SERVICE PARTS LIST

M12™ BRUSHLESS 1/2" (13mm) HAMMER-DRILL

REVISED BULLETIN

DATE Feb. 2014

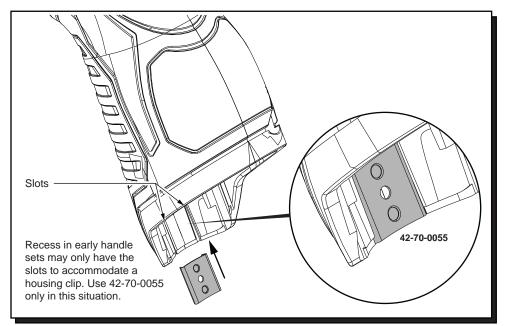
Early M12™ Handle Sets utilize Housing Connection Clip No. 42-70-0055. Install this clip design by aligning the side rails of the clip with the two slots in the handle set. Gently push into place with the aid of a small flat blade screwdriver or a similar instrument. Be sure that the clip is properly seated in both slots and that the clip is flush to sub-flush to the end of the handle set. To remove the clip, use the same small flat blade screwdriver or a similar instrument and push the clip out of the handle set. If the clip is loose or will not stay in place, a needle nose pliers can be used to gently bend/pinch the side rails of the clip. If the clip is damaged do not use, replace with a new 42-70-0055 housing clip.

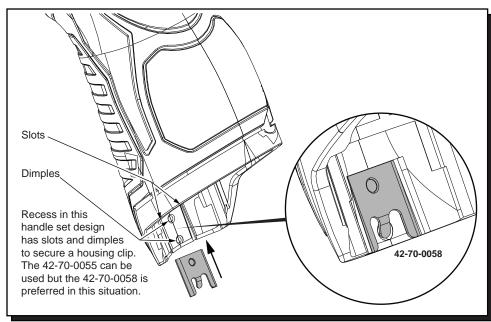
Updated M12™ Handle Sets utilize **Housing** Connection Clips No. 42-70-0055 and 42-70-0058. (The 42-70-0058 is a preferred upgrade). Install this clip design by aligning the side rails of the clip with the two slots in the handle set. Gently push into place with the aid of a small flat blade screwdriver or a similar instrument. Be sure that the clip is properly seated in both slots and that the tab of the clip snaps down in the round dimpled cavity of the handle set. Be sure that the clip is flush to sub-flush to the end of the handle set. To remove the clip, use the same small flat blade screwdriver or a similar instrument and lift up on the clip tab while pushing the clip out of the handle set. Use a needle nose pliers to gently rebend the clip tab if necessary. If the tab on the clip is damaged during this process and is loose or will not stay in place, replace with a new 42-70-0058 clip.

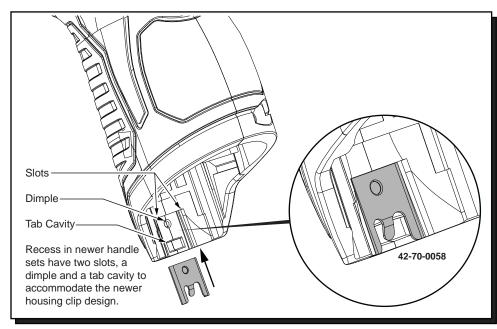
Newer M12™ Handle Sets utilize **Housing** Connection Clip No. 42-70-0058. Install this clip design by aligning the side rails of the clip with the two slots in the handle set. Gently push into place with the aid of a small flat blade screwdriver or a similar instrument. Be sure that the clip is properly seated in both slots and that the tab of the clip snaps down in the rectangular cavity of the handle set. Be sure that the clip is flush to sub-flush to the end of the handle set. To remove the clip, use the same small flat blade screwdriver or a similar instrument and lift the clip tab out of the cavity while pushing the clip out of the handle set. Use a needle nose pliers to gently rebend the clip tab if necessary. If the tab on the clip is damaged during this process and is loose or will not stay in place, replace with a new 42-70-0058 clip.
